PROJECT: SES Solar One

RE: SES Solar One Project
Applicant's Responses to CURE Data Requests 276-380
CURE Data Requests Set 3

In Response to CURE Data Requests
Set 3, Data Requests 276-380

Application for Certification (08-AFC-13)

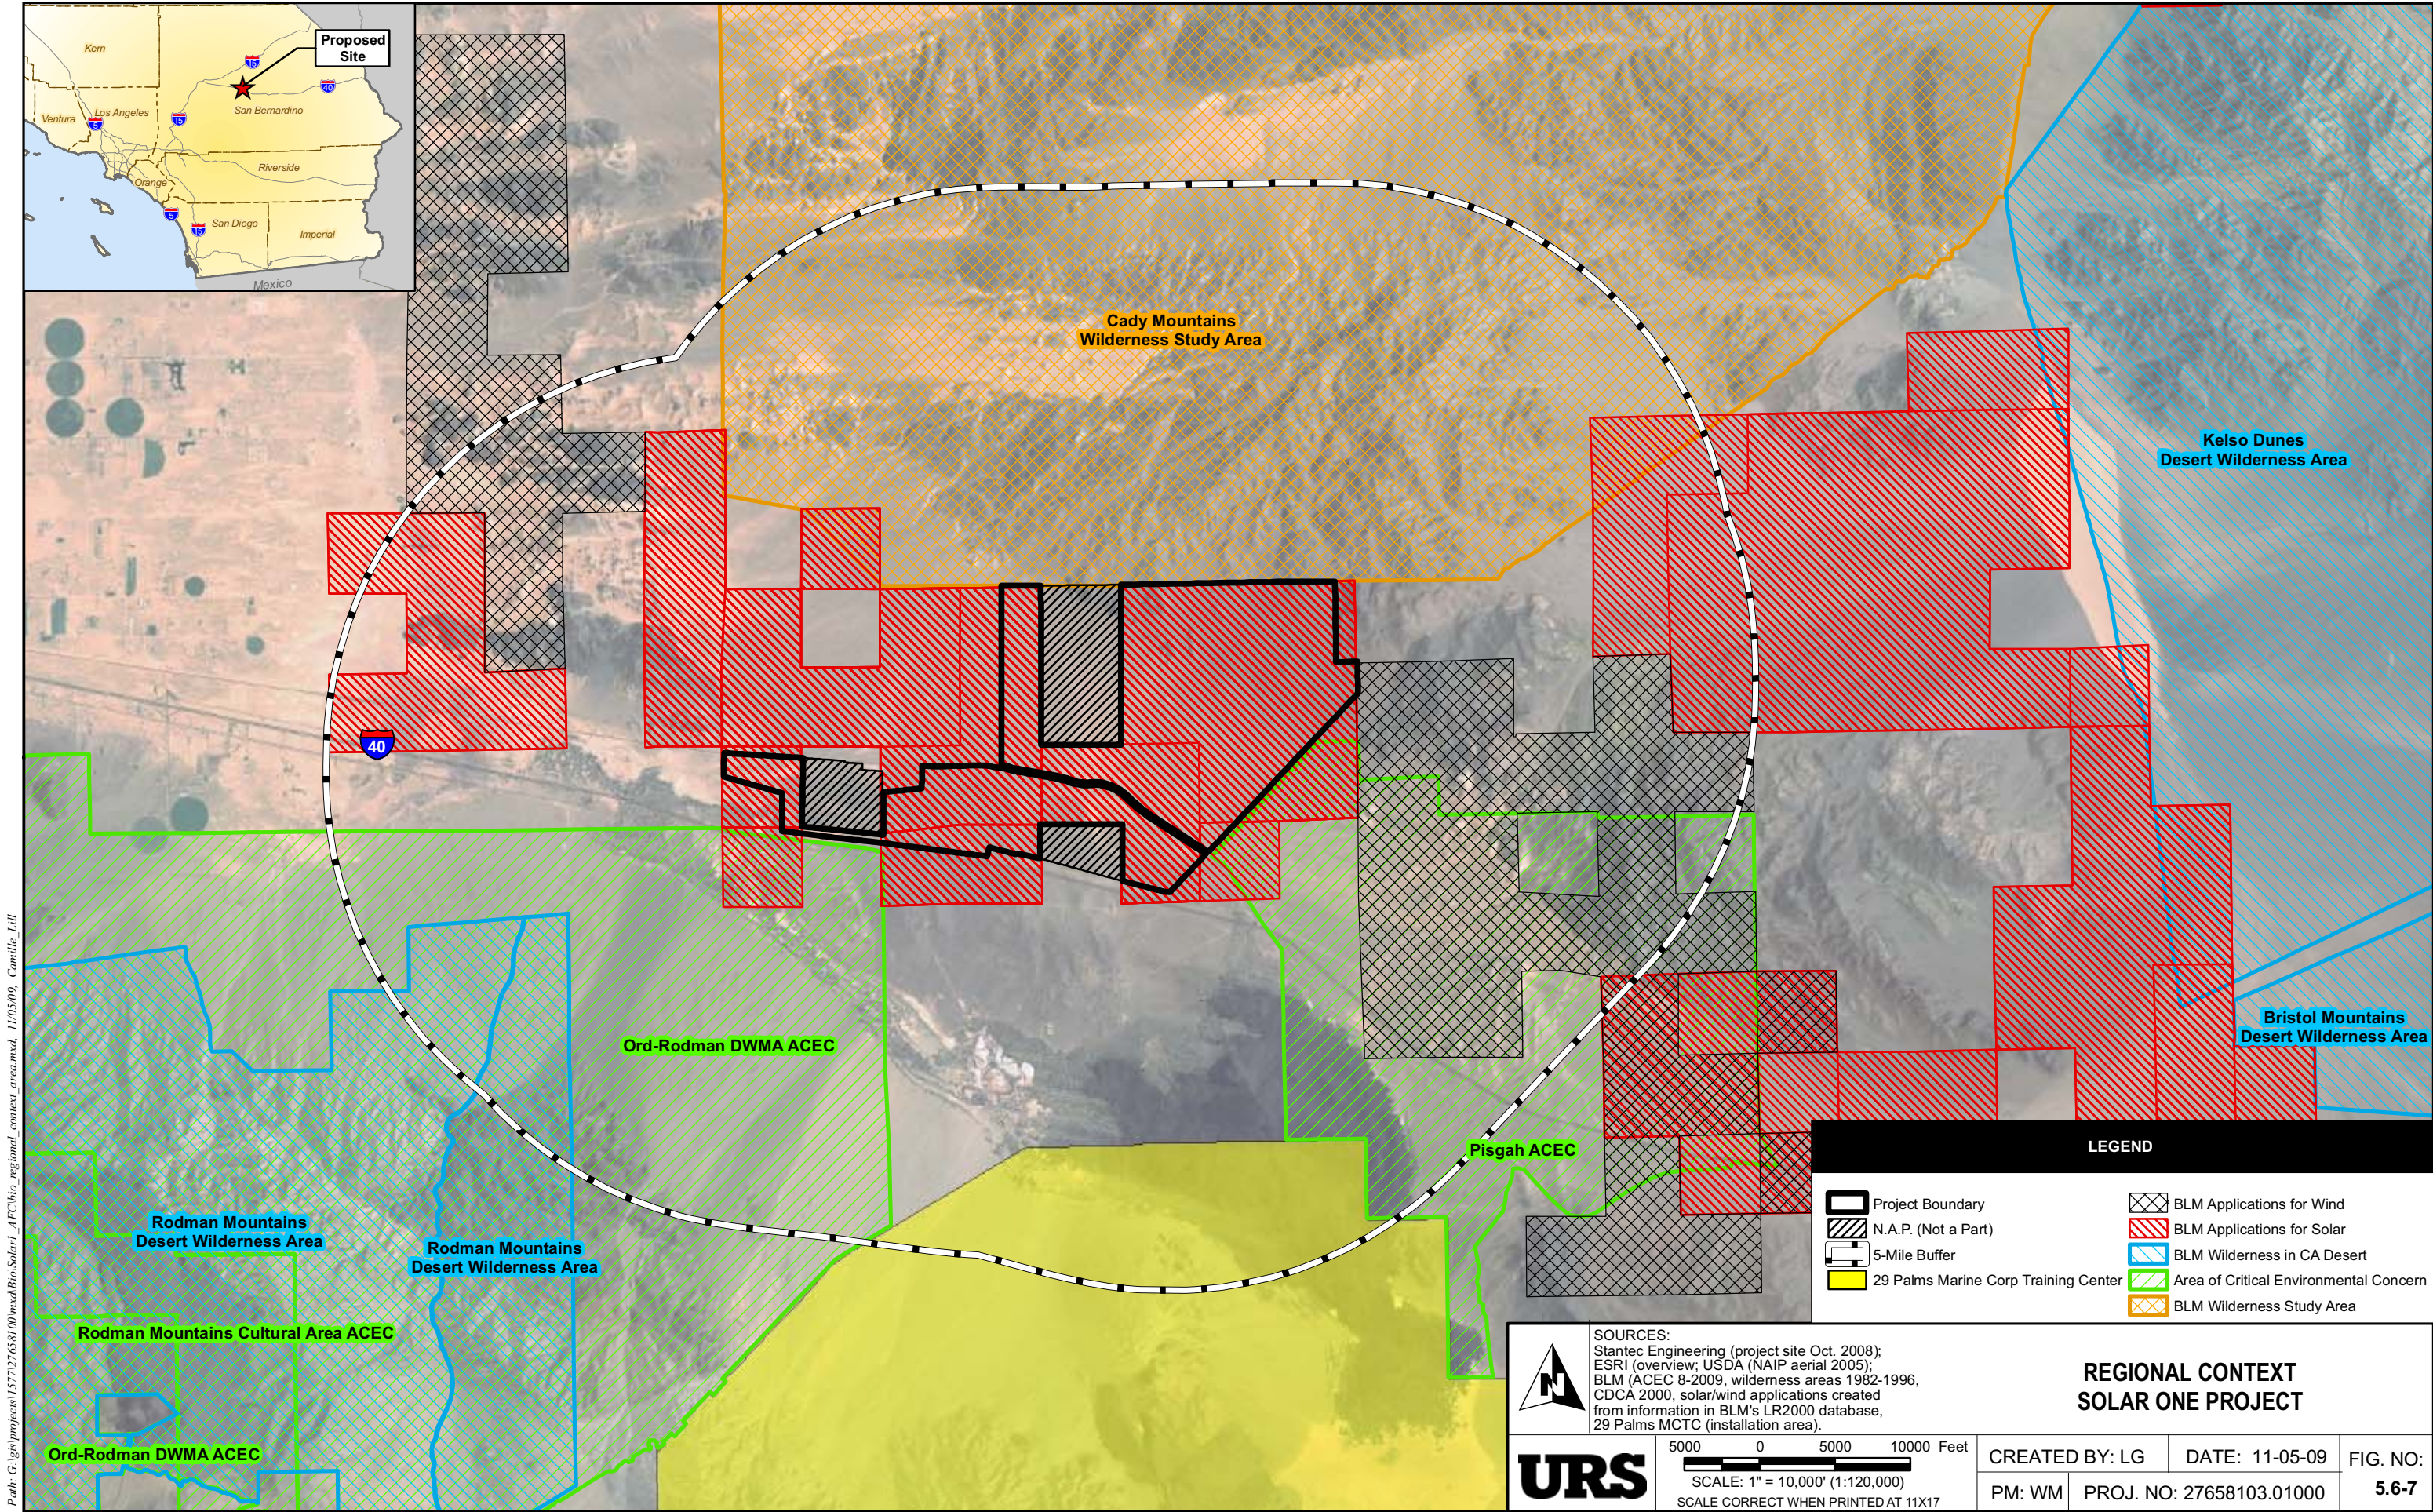
Data Request 363: Please provide a map that clearly depicts the locations of special-status species occurrences in relation to Project features (e.g., boundaries).

Response: AFC Figure 5.6-4 shows the locations of special status species occurrences in relation to Project boundaries.
